UNITED STATES PATENT AND TRADEMARK OFFICE

APPLICATION NO.	FILING DATE	FIRST NAMED INVENTOR	ATTORNEY DOCKET NO.	CONFIRMATION NO.
09/922,057	08/03/2001	Charles Arthur Risdall	38572/26217	7578

# Office Action Summary

### **DETAILED ACTION**

FIG. 7

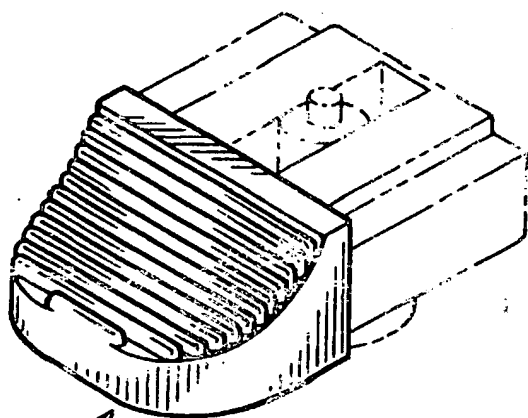
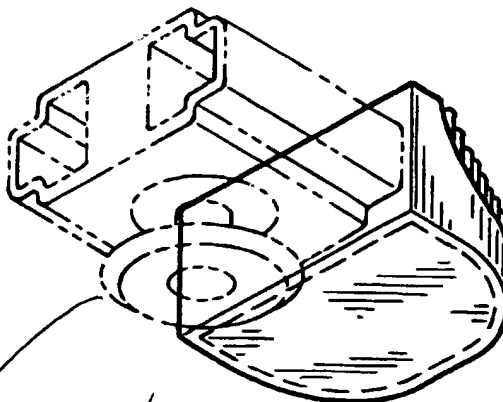
Schwartz discloses an end cap for closing an open end of a piece of furniture comprising a butt portion and an attachment portion (see attached marked-up drawings), the bottom side of the attachment portion having a threaded insert, such as shown in Fig 7, a threaded glide member

cooperatively engaged with the threaded insert; wherein the threaded glide member to the piece of furniture allows elevating or leveling of the piece of furniture. Therefore, it would have been obvious to modify the structure of Barecki et al by providing the bottom side of the attachment portion with a metallic threaded insert, and a threaded glide member cooperatively engaged with the threaded insert for the purpose of elevating or leveling of the piece of furniture, as taught by Schwartz, since both teach alternate conventional end cap structure for a piece of furniture, used for the same intended purpose, thereby providing structure as claimed.

*butt portion*

*attachment portion*

*threaded glide member*
